EXETER  
COLLEGE  
OXFORD

A New Quad at Walton Street  
**Supplementary Planning Document**  
July 2013

This addendum statement responds to the issues arising from the recent statutory consultation process, as well as the consultation undertaken by Exeter College directly, in support of the statutory processes.

The addendum report is a formal submission to Oxford City Council and should be read in conjunction with the applications new paragraph 13/00832/FUL for “Redevelopment of existing student accommodation and teaching site comprising the demolition of all buildings, with exception of the 1913 Ruskin College facade to Walton Street and Worcester Place, and erection of 90 student study rooms, 3 Fellows/Staff residential rooms, teaching facilities, library archive, social space, landscaping and associated works”; and 13/01075/LBD for “External alterations involving demolition of south and west facades of 1913 building, demolition of 1930’s, 1960’s and 1980’s extensions, and removal of existing roof. Erection of four storey extension to rear to provide 90 student study rooms, 3 Fellows/Staff residential rooms, teaching/lecture facilities, library archive and social space. Erecti

Existing sections along Worcester Place

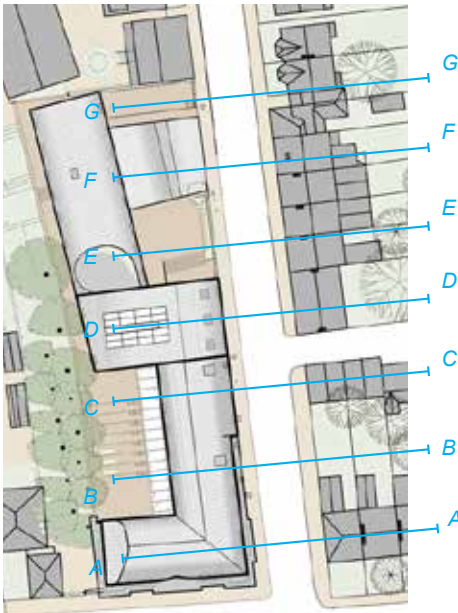
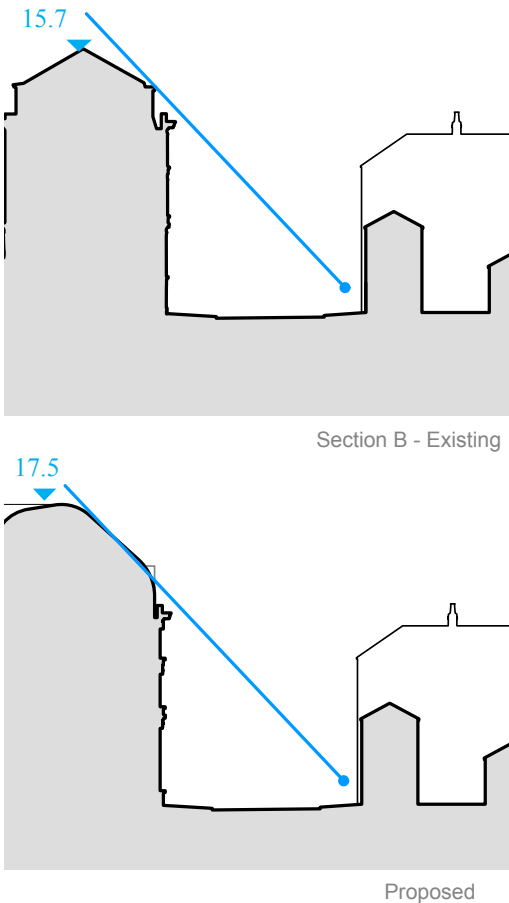
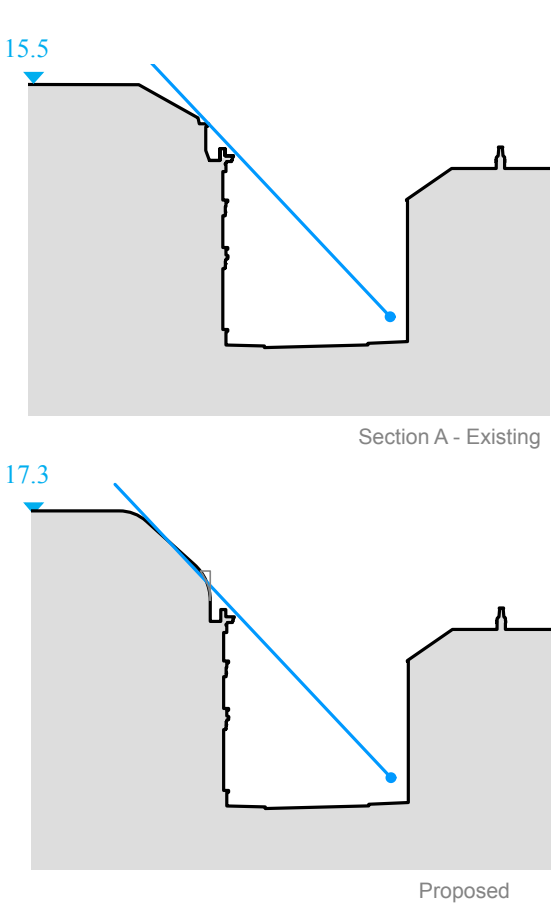
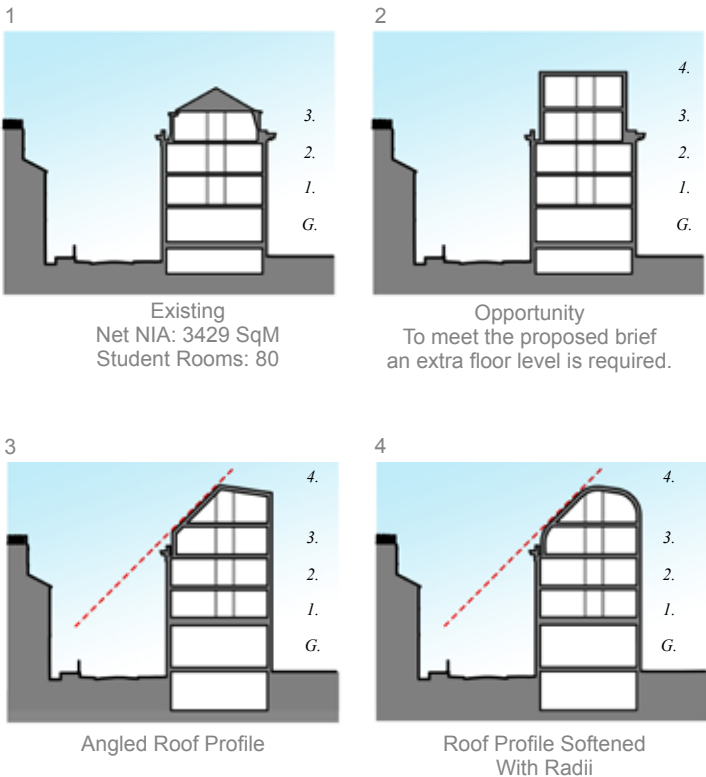
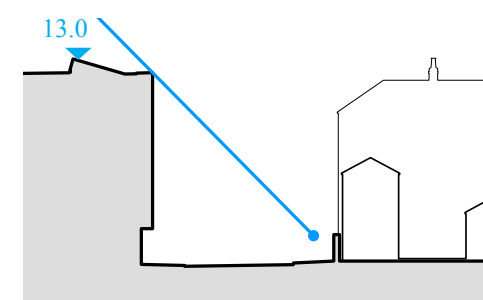
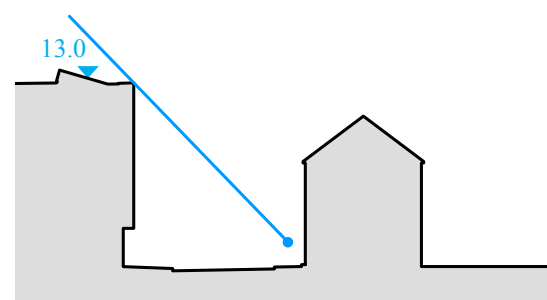
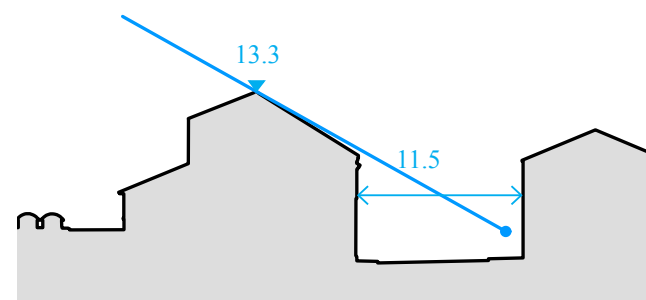
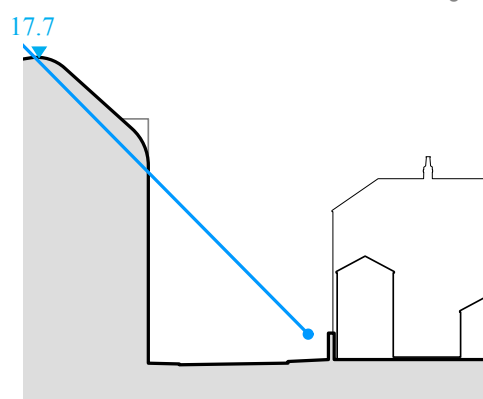
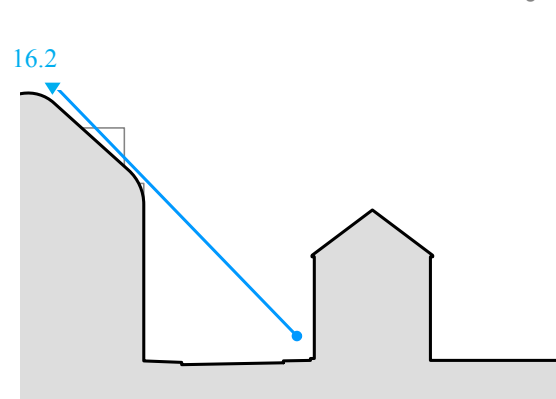
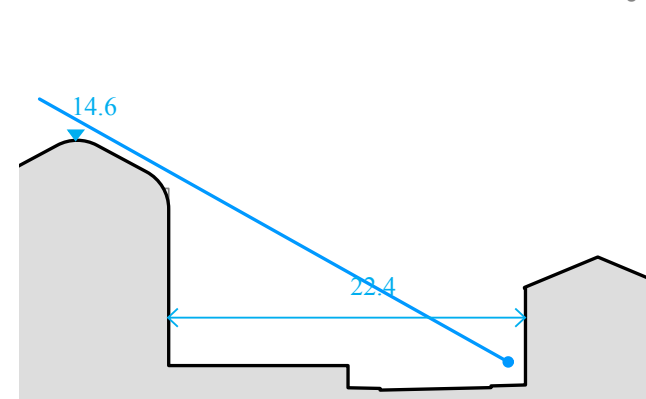
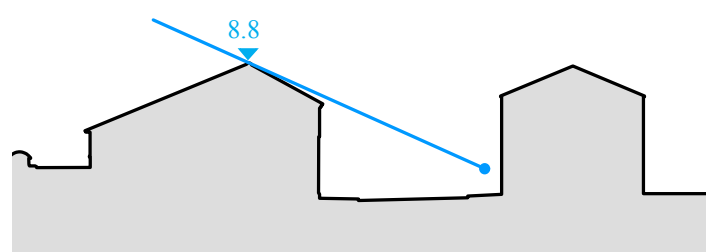
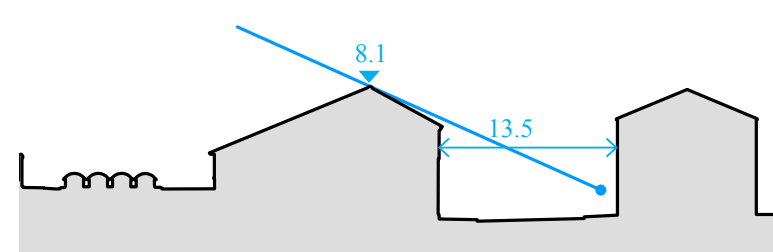
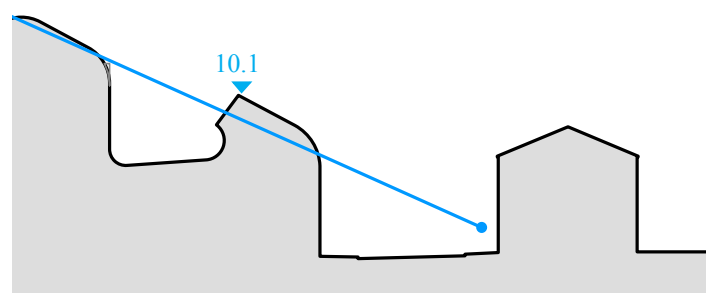
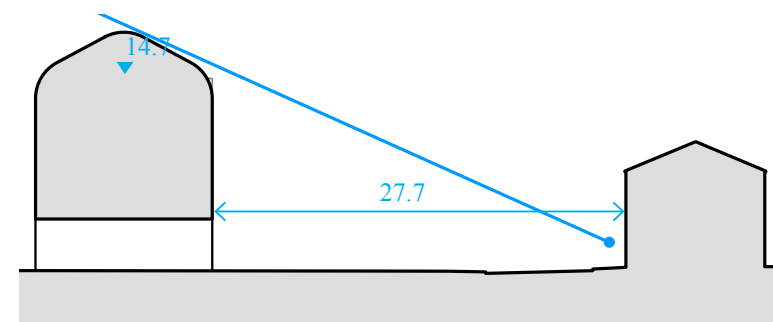
- 1) The decrease in light angles owing to extra height, including the large dormer windows
- 2) The missing shadowing analysis for December 21st and March 21st
- 3) The potential overall reduction of light to their homes.

The following sectional analysis demonstrates that only in two cross sections (C and F) there is a modest increase in the height of the building. There is no significant change in three of the cross sections (A, B and D) whilst there is a substantial improvement in two of the cross sections (E and G).

Analysis of the Ruskin building's roof profiles led the team to explore the concept of extending the existing mansard vertically to generate new space. We found that extending the Ruskin roof at an angle within closest viable proximity to the existing mansard permits an additional storey of expansion, required to encompass the program and rooms outlined in the brief. To soften and lower the visual impact of the extended roof and vertical massing we have adopted the principle of the radiused ridge geometry, a new formal language for the Ruskin building, but one familiar to the 19th Century Beaux-Arts eye, or the 21st Century eye attuned to the organic and curvilinear. We found that the radiused roof profiles allowed us to make smooth transitions in building heights and widths along the length of the site in line with the constantly varying planes defining daylight and sunlight envelope.

The limited changes in bulk and massing to Worcester Place has resulted in a positive assessment of sunlight and daylight as shown in 3.1.2 below.

Alternative location for trees and cycles

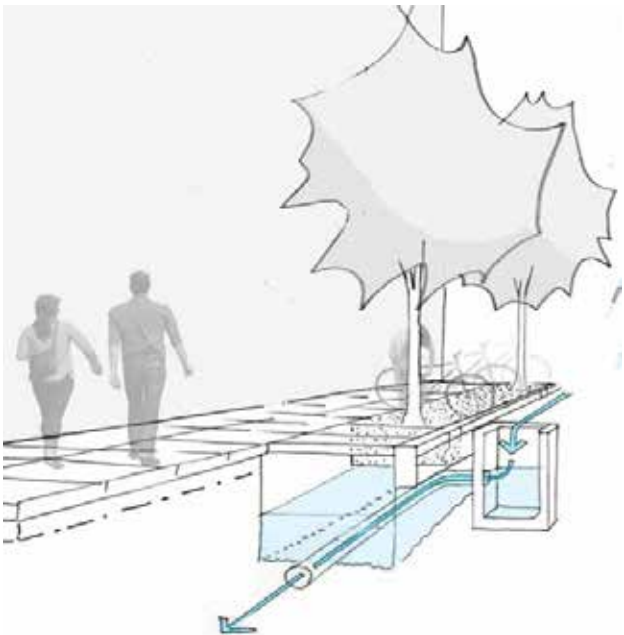
Two principle concerns have been raised in respect of cycle parking: location and management. In respect of location, residents of Worcester Place raised a concern over the noise of bikes being parked and the potential to cause a nuisance to the occupants of the dwellings directly opposite. In response, the Project Team has looked again at the position of the cycles. There is not enough space at the front of the building, on Walton Street to accommodate them. However, it is possible to move the cycle stands closer to Walton Street, positioning them opposite Walton Lane. In this way, it is considered that the prospect of nuisance arising from the cycle spaces can be avoided.

The proposed planting in Worcester Place consists of 3 Hawthorn Trees. These trees have been selected as they are of an appropriate scale for Worcester Place, being of limited height and bulk, but will nonetheless provide a welcome touch of greenery to the street. They will be planted in tree pits, ensuring that there is no risk of root encroachment on adjacent buildings. As with the position of the cycle stands, the location of the trees will also move closer to Walton Street.

Section through Lecture Hall

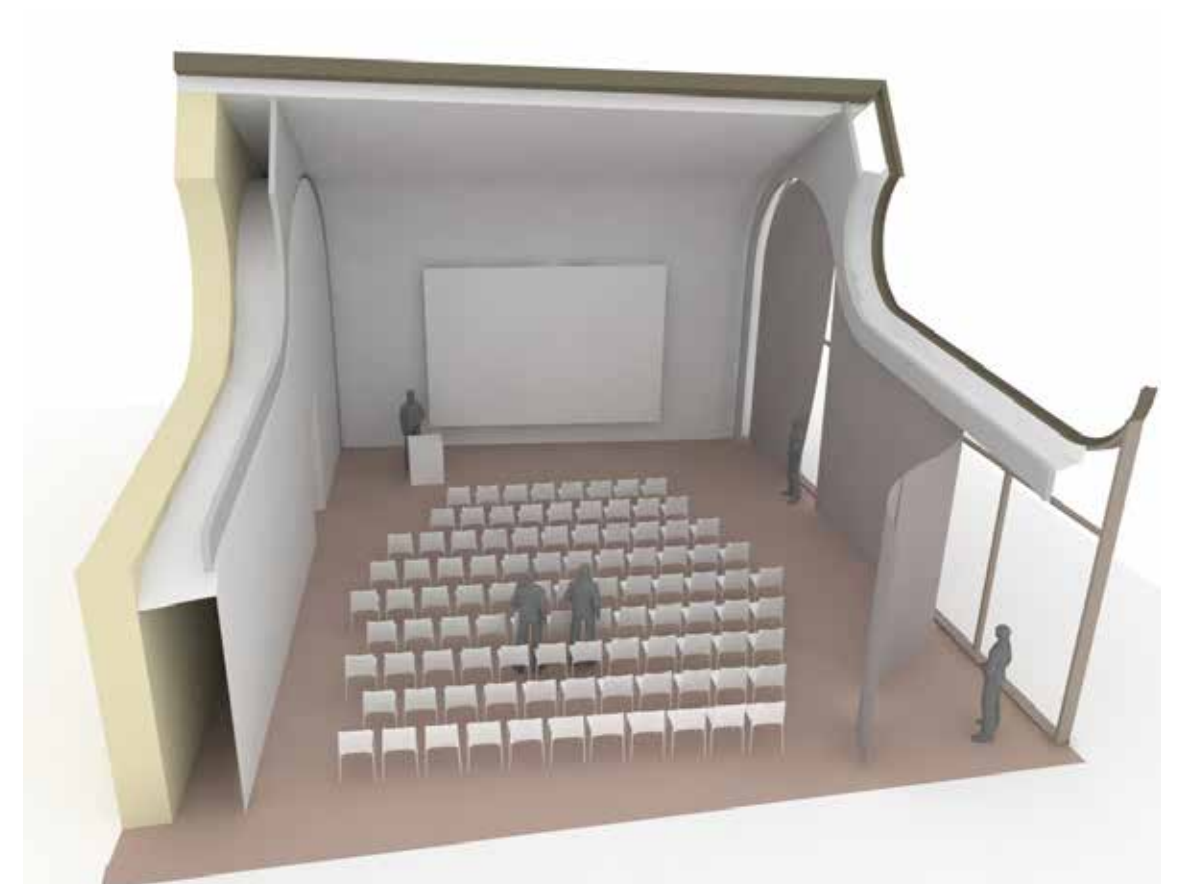
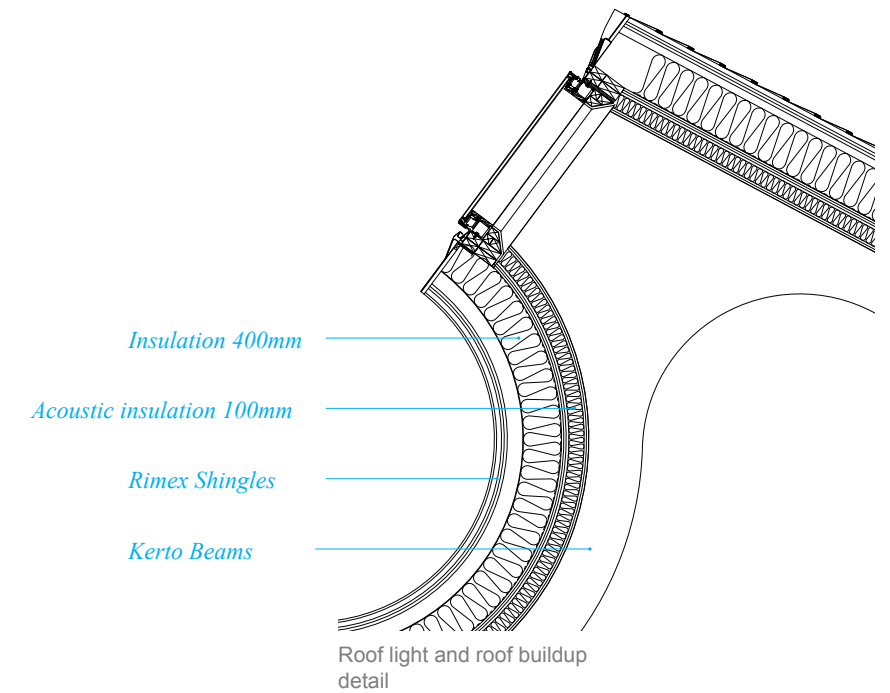
The auditorium positioned on Worcester Place is designed primarily for use as a lecture hall for teaching purposes. It will also be available for occasional recitals, talks and public events, should the community wish to use it. It will not be used for any events involving amplified music.

The walls of the auditorium include insulation of half a metre thickness to ensure that no disturbance occurs either to the students residing in the building or to the residents of Worcester Place.

Service Lane

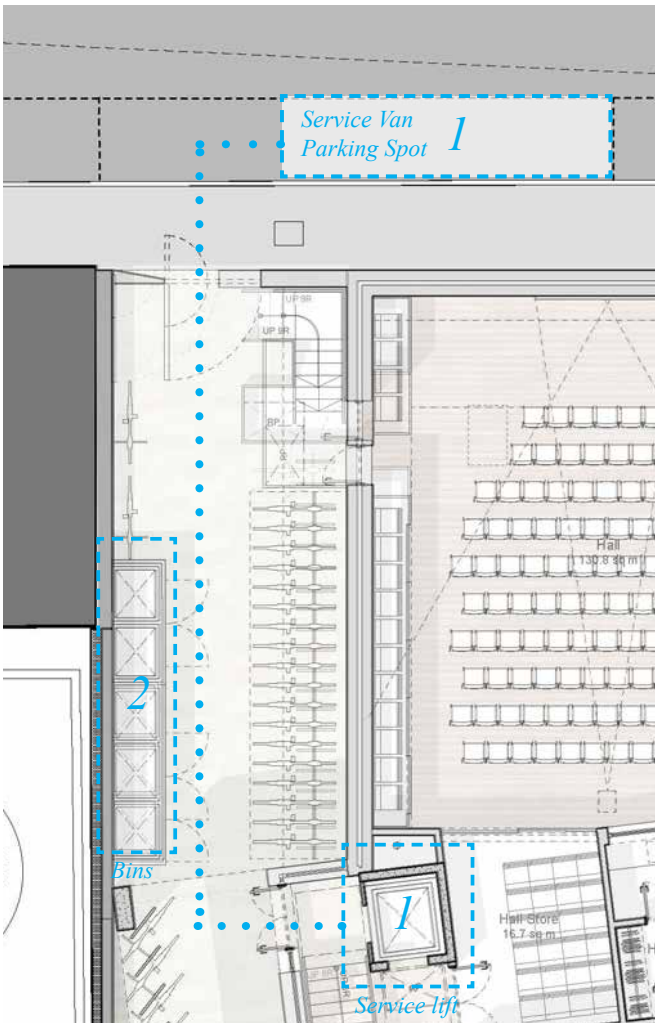
Concern was expressed by a resident of Worcester Place with regard to the timing of collections and deliveries to the site. The level of servicing is anticipated to be very similar to that which occurred when Ruskin College was in operation at the site, circa 3-4 deliveries per day.

The College proposes to manage servicing of the Walton Street Quadrangle in a similar way to the approach at the Turl Street Campus as many of the same contractors will be involved. The present arrangement is that no deliveries/ collections occur before 7.30am and none later than 4pm and it is envisaged that this will continue for the Walton Street site.

1. Waste Collection - 10:00 am To avoid causing disturbance to residents and traffic
2. Delivery - Off peak hours for traffic i.e. 7:30am - 8:30am and 10:00 -16:00pm

### Lowering Windows to match the new floor level

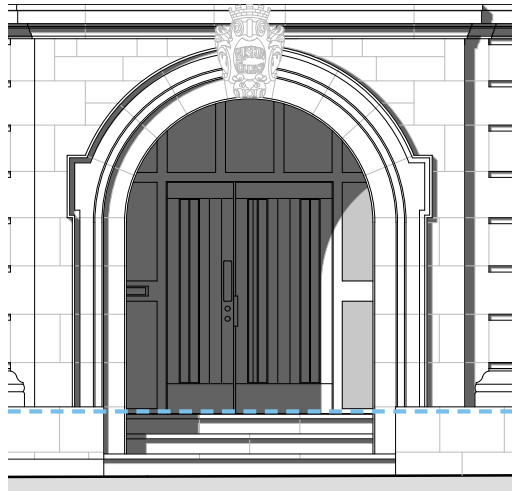
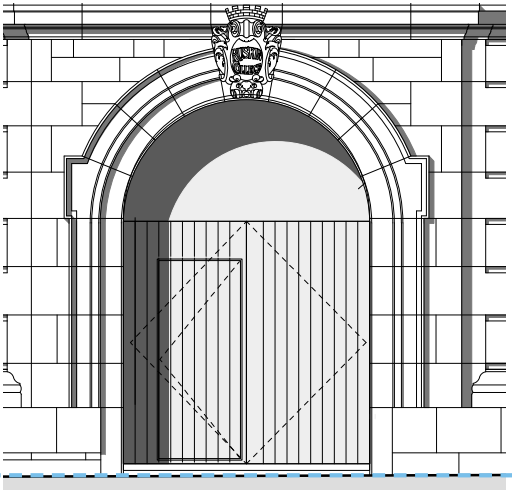
The team consultant structural engineer has demonstrated that full reconstruction of Ruskin Building internal floors is necessary in order to achieve functional and accessible floor plans and levels, since the filler-joist floor structure cannot accommodate the moving of all the structural partition lines and numerous penetrations for new services. Once the ground floor has been lowered to make the whole building accessible from Walton Street the ground floor window openings become uncomfortably high above ground floor level to serve their purpose.

For this reason the Project Team proposes to add two extra panes of glass to lower the sill of the ground floor windows. This allows extra window height for increased light levels and a proportionate relationship to the new primary floor level.

The sills and aprons of the ground floor windows will be lowered to suit the new ground floor level, window surrounds will be extended and the existing inscribed apron stones reset at a lower level. The ground floor windows will be replaced with new steel-framed double glazed windows with glazing bars to match the existing, extended by two extra panes in height.

Rimex Sample Panels - Evolution

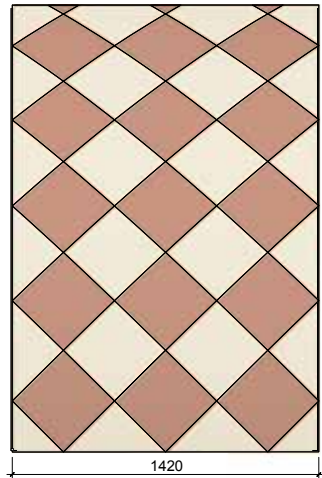
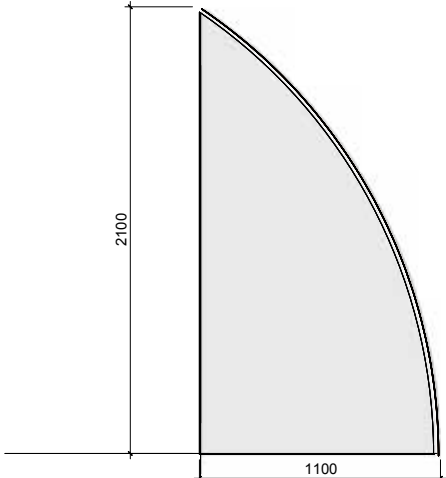
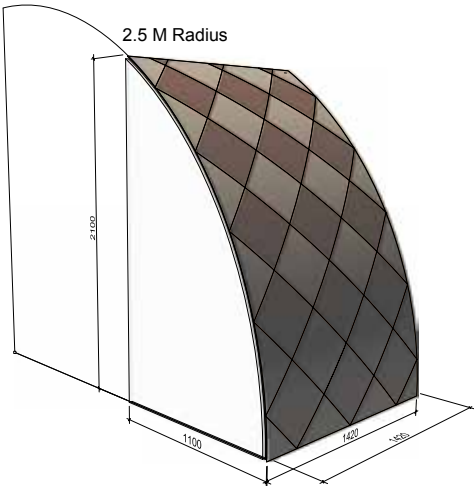
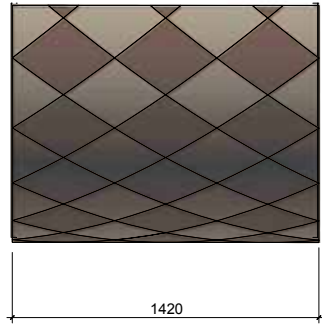
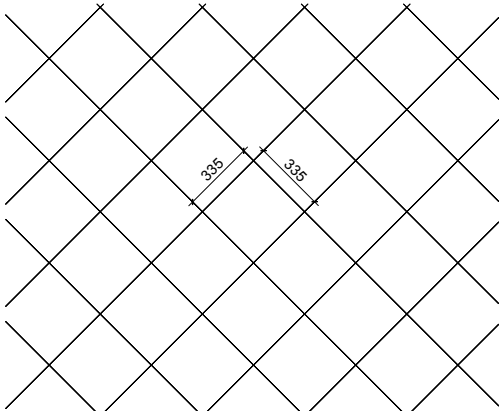
The principal concerns raised over the Rimex stainless steel cladding material relate to colour and reflectivity levels of the shingles. The Project Team, has taken further actions to reduce the glow through manufacturing processes such as sanding and bead blasting. The results of these tests are manifested in a set of large scale mock up panels on display at Ruskin College. The three panels range from highly reflective to nonreflective. The feedback gathered by the Team during public consultation and OCC meetings seems to be in favour of the “low reflective” mock-up panel as the material has a subtle range of tones as seen from different angles of view, compared to the nonreflective cladding. The concerns of direct light reflections into Worcester Place residents windows have been analysed further and no significant reflectivity was found possible as the Rimex cladding is predominantly facing north.

Rimex textured Bronze and textured Champagne; top layer sanded and bead blasted (nonreflective)
